Koala Protection on Heathcote Road at Deadmans Creek

REF submissions report

April 2025

Appendix A – Revised Design

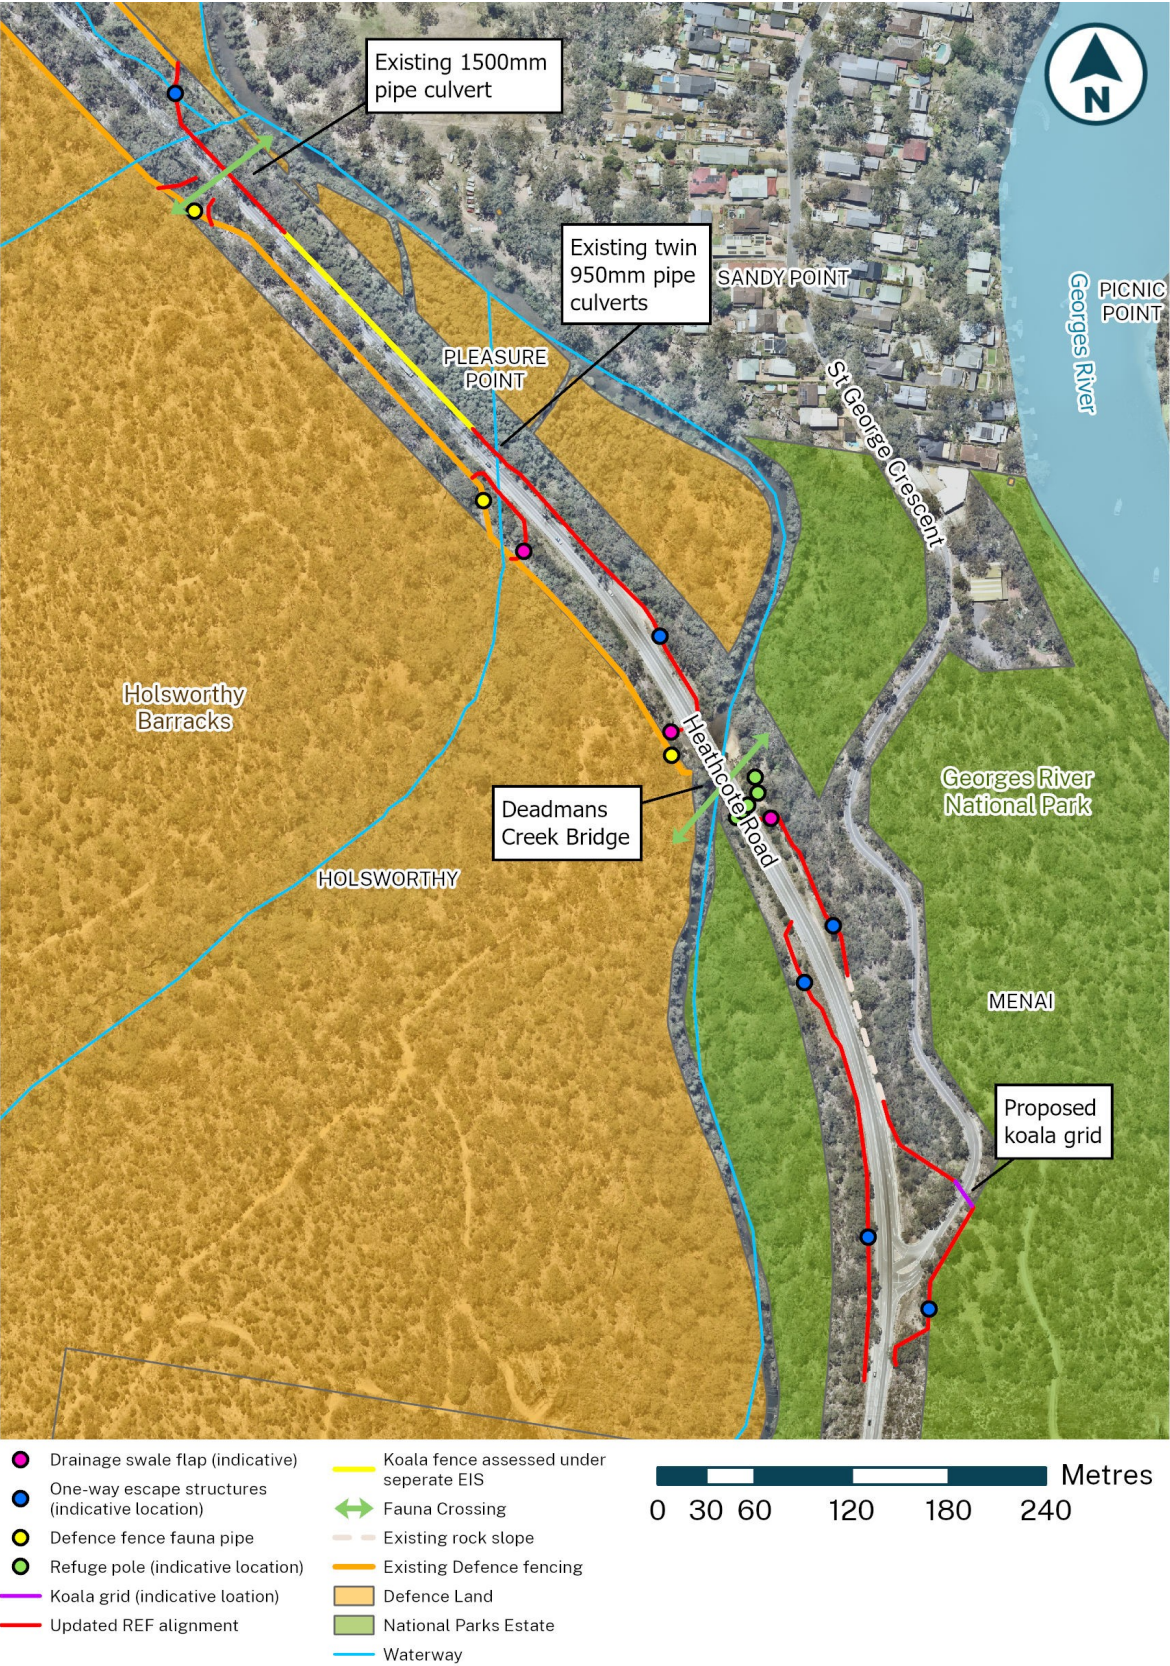
Transport proposes to modify the alignment of the fencing on both sides of St George Crescent. The new fencing alignment is shown in Figure 3-1 below.

The change in fence alignment would require about 120 square metres less vegetation clearing than the original proposal. This would reduce the impacts of the proposal on biodiversity as it would minimise impacts to habitat for fauna such as koalas.
